Jefferson Proving Ground Madison, Indiana

Draft Final Phase II Remedial Investigation

Re: Draft Final Remedial Investigation
Jefferson Proving Ground,
Madison, IN

FIGURE 2-1

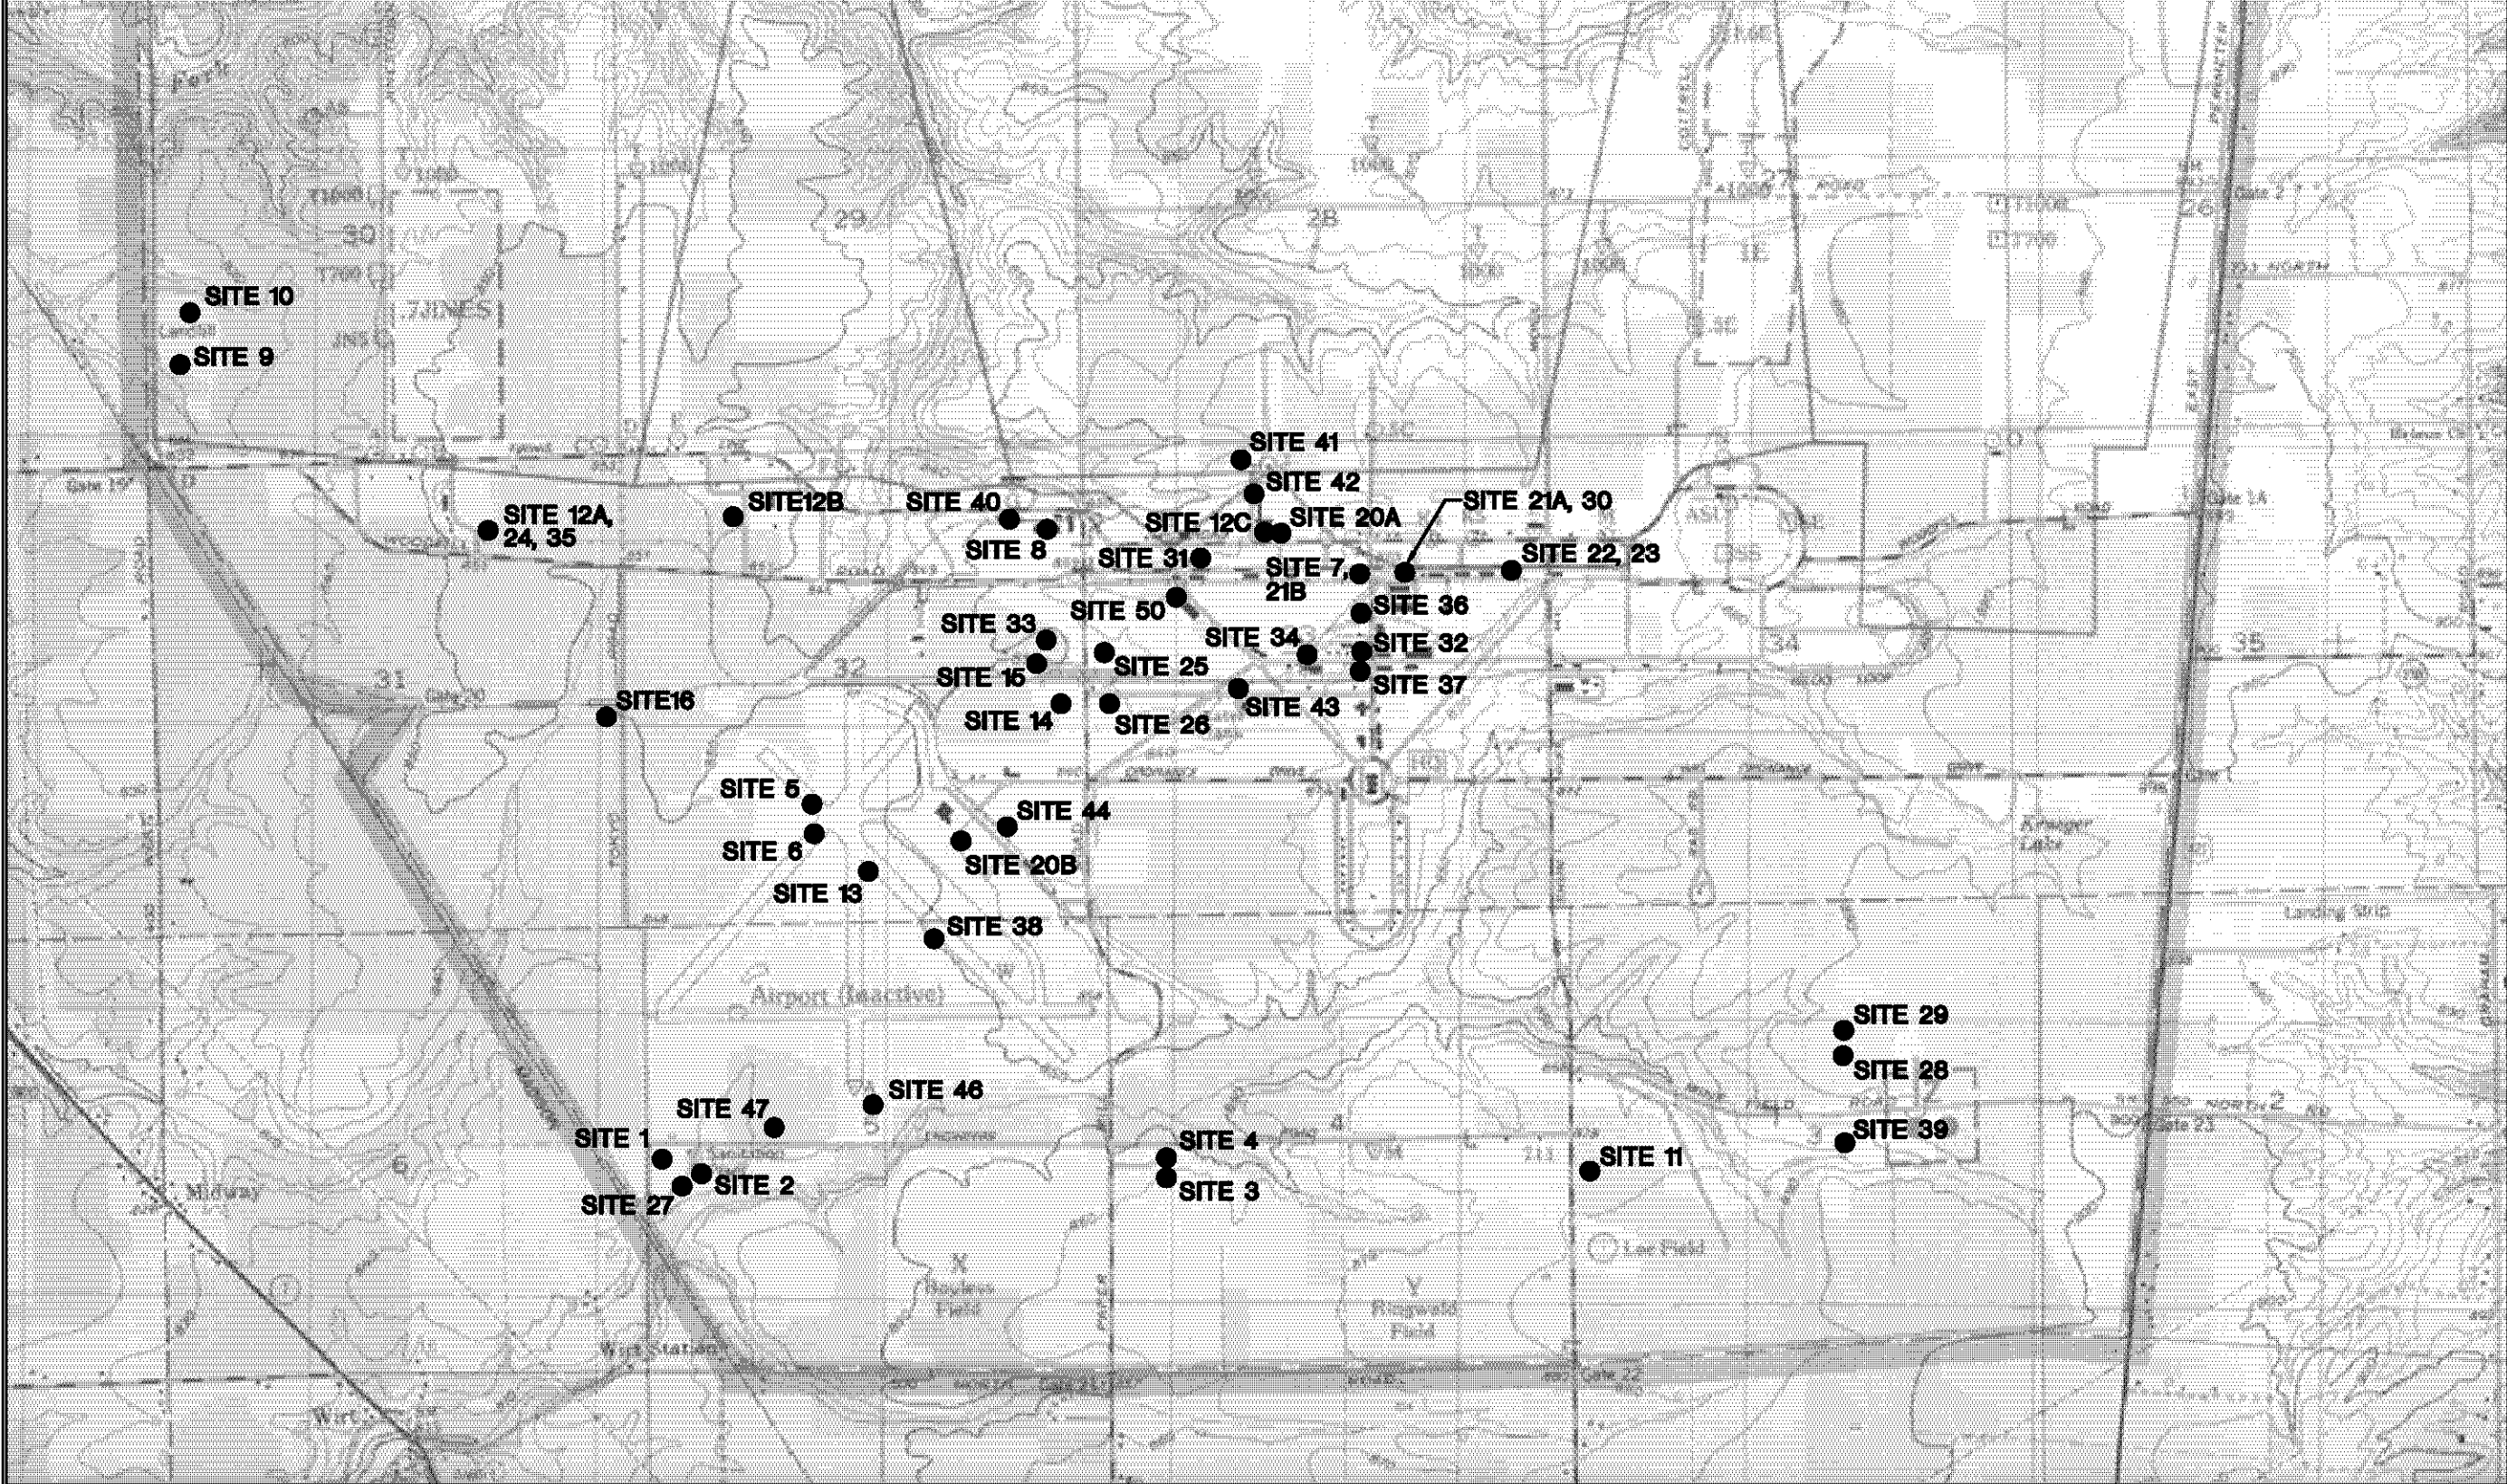
| Comment # | Section | Comment (EPA/IDEM as indicated in comment number) | Original Response to Comment (ET) | MW Revised Response (if applicable) | Agency Concur |
|-----------|--|--|---|--|---------------|
| EPA204 | 12.1, Figure 2-1 | 21. Section 12.1, Site Characteristics, Page 12-1, Paragraph 4: The text indicates that surface water runoff appears to flow toward a small pond and the pond also receives runoff from a ditch that flows west along the Firing Line from as far away as Building 602. It also states that the pond discharges to the west via a drainage ditch and ultimately enters Middle Fork Creek and references Figure 2-1. The surface water pathway is not clearly documented on Figure 2-1 or any other figure found in this report. It is recommended that the surface water ecosystems be clearly presented . | Figure 2-1 will be revised to show the drainage of the pond to the perimeter fence, beyond which is private property. The area eventually drains into Middle Fork Creek to the northwest. | Comments addressed per ET's response. | |

Figure 2-3. Interpreted Bedrock Geology Subcropping Beneath the Glacial Till Based on Monitoring Well Data

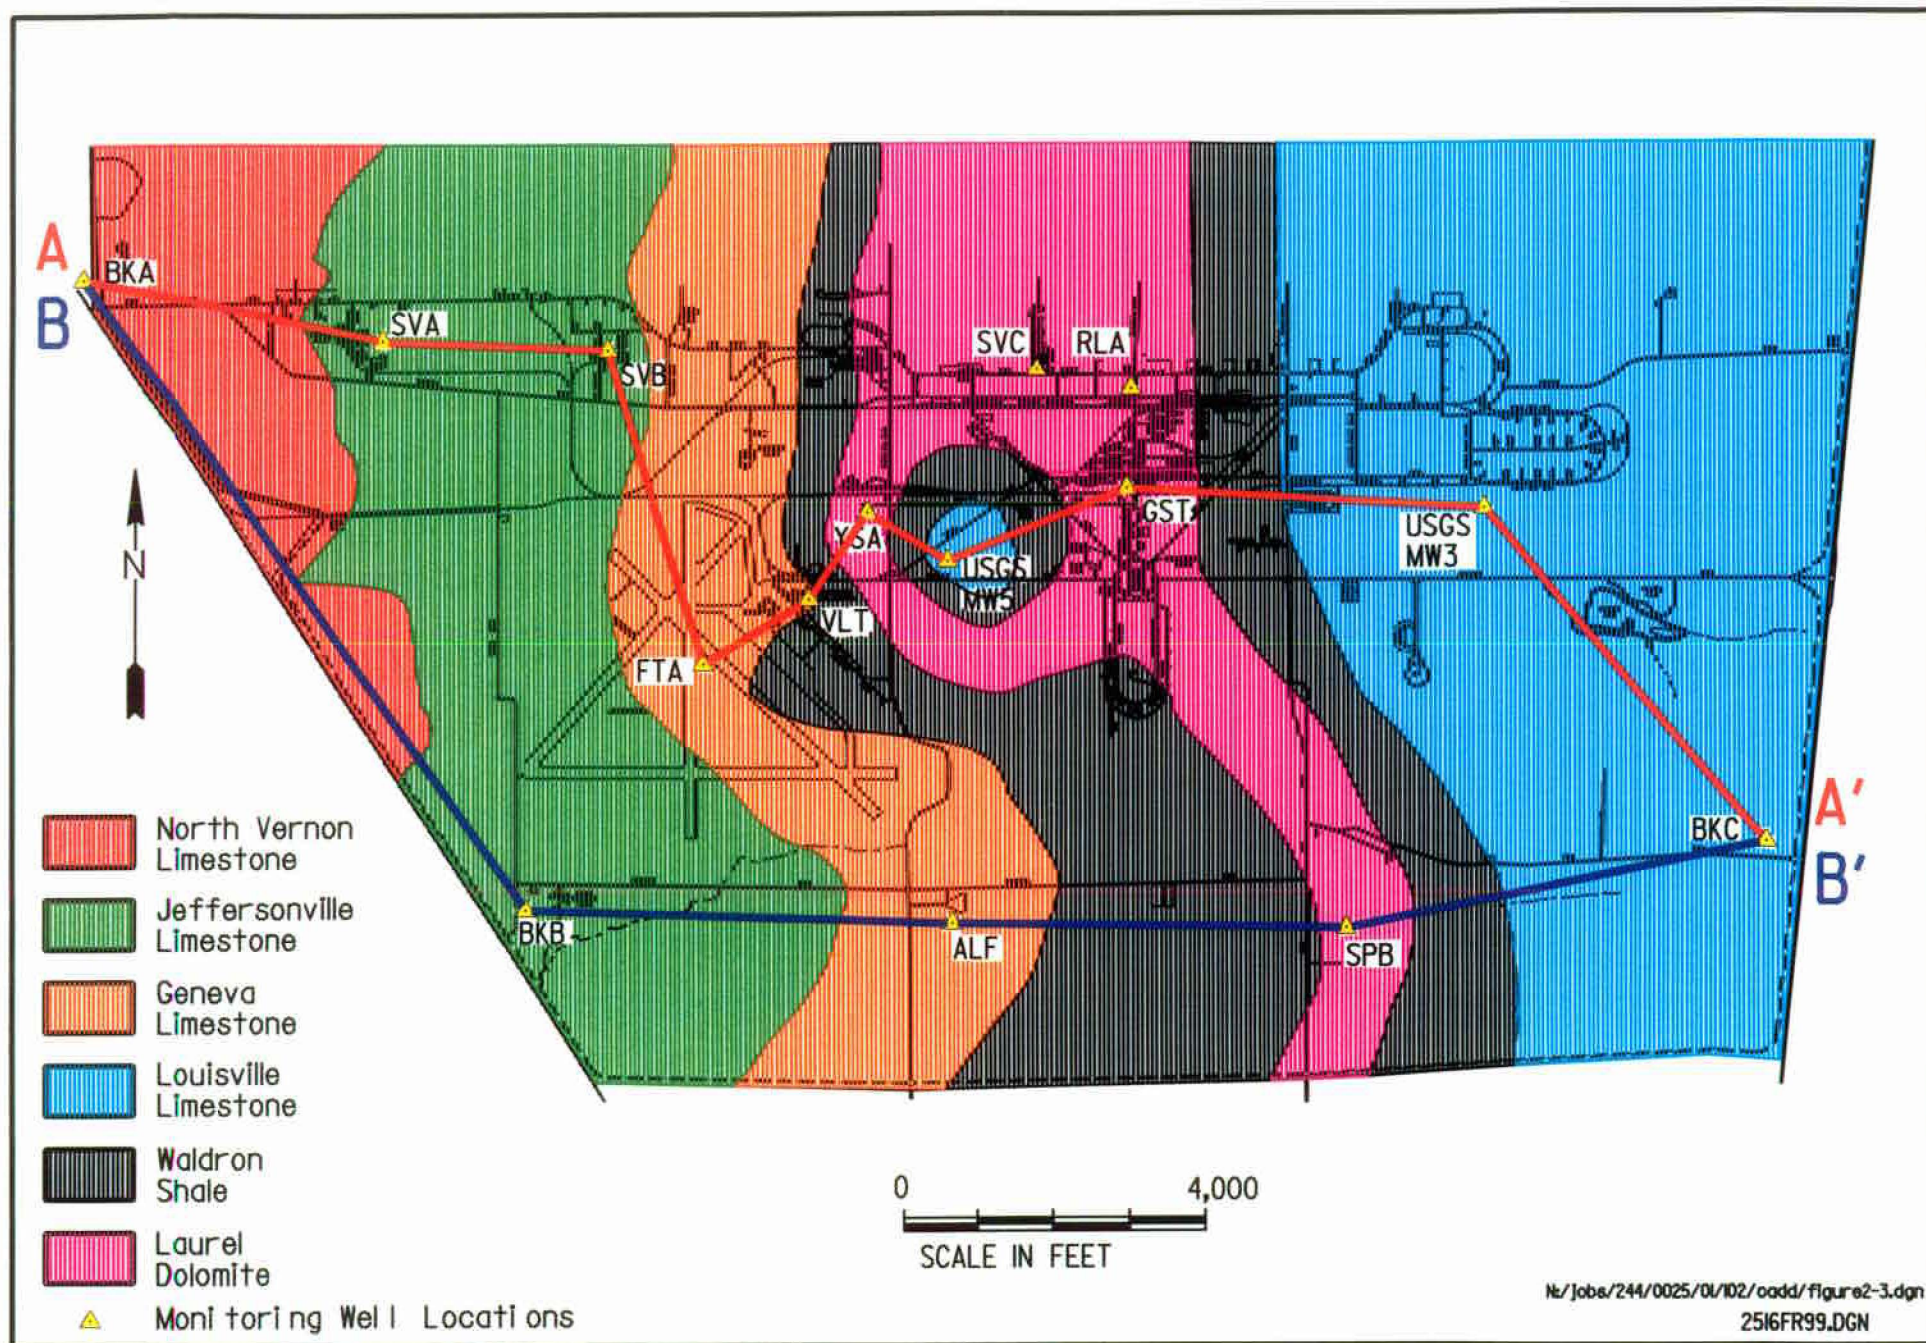
| Comment # | Section | EPA 31 May 2002 Comment | Army Response Submitted 21 June 2002 | EPA Evaluation of Response | Resolved (yes/no) |
|-------------------------|---------------|---|---|----------------------------|--------------------|
| EPA 1 | Sec 2.3.1 | Bedrock Geology: Paragraph 2, Figures 2.3, 2.4 And 2.5 do not provide information, they are unreadable. | These figures were intended to be included as color figures, however your copy of the Draft Final RI inadvertently included black and white copies. We apologize for this and the color copies are included for replacement. | | Yes – Sent 6/21/02 |

| Comment # | Section | IDEM 30 May 2002 Comment | Army Response Submitted 21 June 2002 | IDEM Evaluation of Response | Resolved (yes/no) |
|-----------|---------------|--|--|-----------------------------|-------------------|
| IDEM 6 | Sec 2 | Figures: Figures 2-3, 2-4, 2-5, 2-6, and 2-10 are unreadable. Figure 2-10 is a mass of black with white lines in it. They need to be replaced with legible figures in order for IDEM staff to properly interpret the information they are presenting. | These figures were intended to be included as color drawings. We have learned that a number of report copies were distributed with illegible black and white copies. We apologize for this oversight and attached are color copies as replacements. | Response is adequate. | Yes |

Figure 2-7. Stratigraphic Column for JPG South of the Firing Line

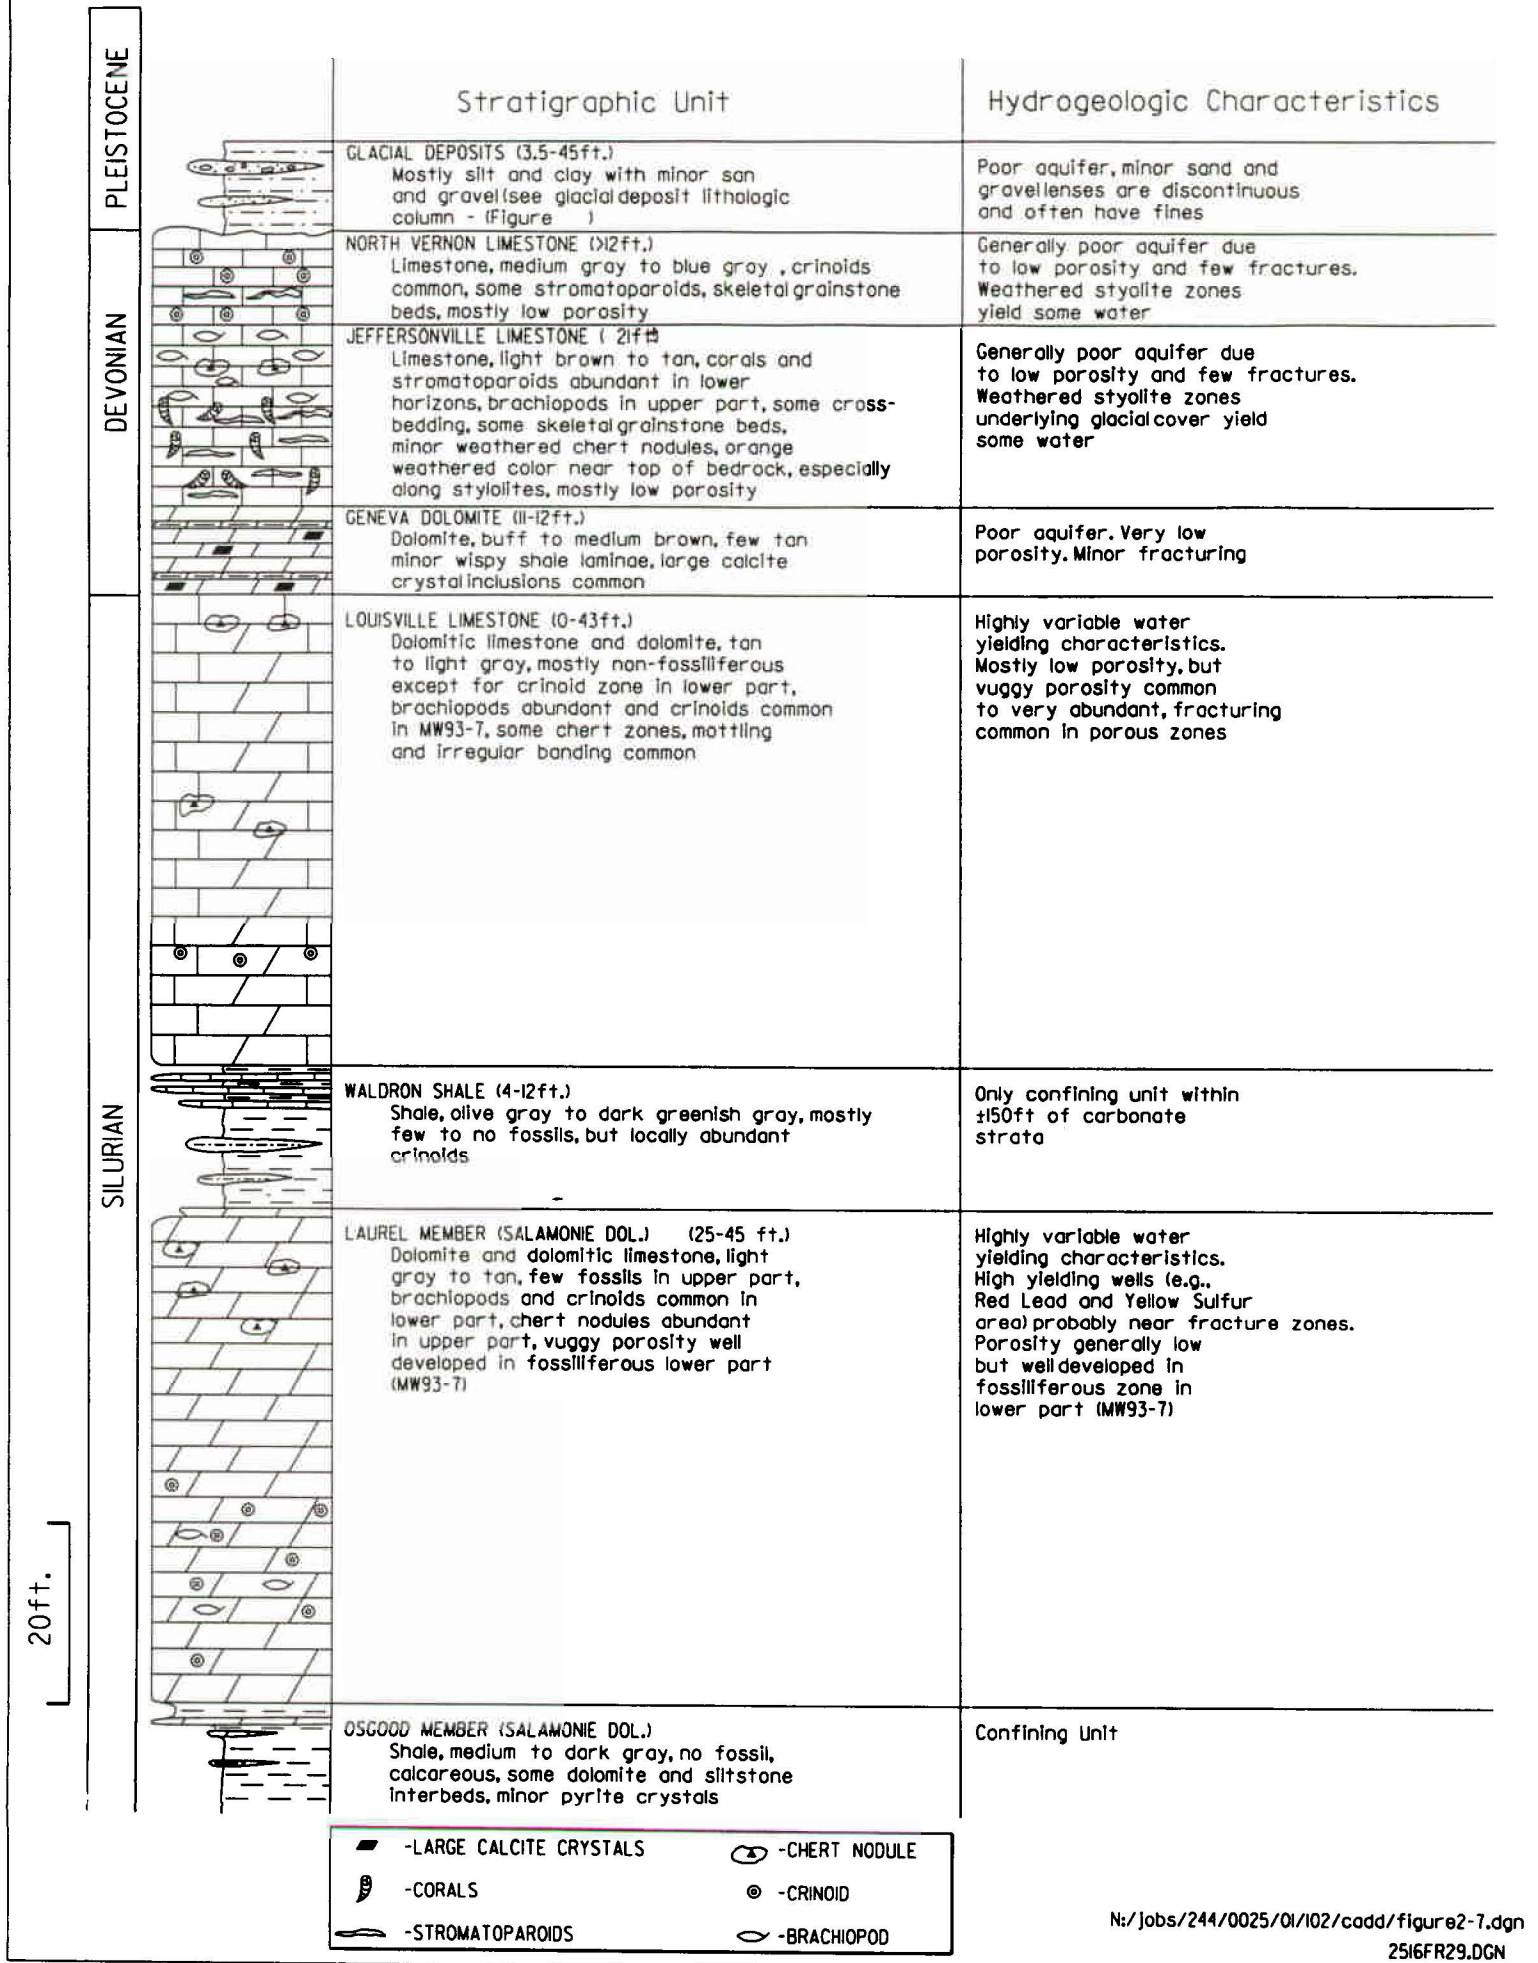
| Comment # | Section | EPA 31 May 2002 Comment | Army Response Submitted 21 June 2002 | EPA Evaluation of Response | Resolved (yes/no) |
|-------------------------|---------------|---|---|----------------------------|--------------------|
| EPA 2 | Sec 2.3.1 | Bedrock Geology: Paragraph 5, Figure 2-7 do not information on Till and Bedrock units, they are unreadable. | These figures were intended to be included as color figures, however your copy of the Draft Final RI inadvertently included black and white copies. We apologize for this and the color copies are included for replacement. | | Yes – Sent 6/21/02 |
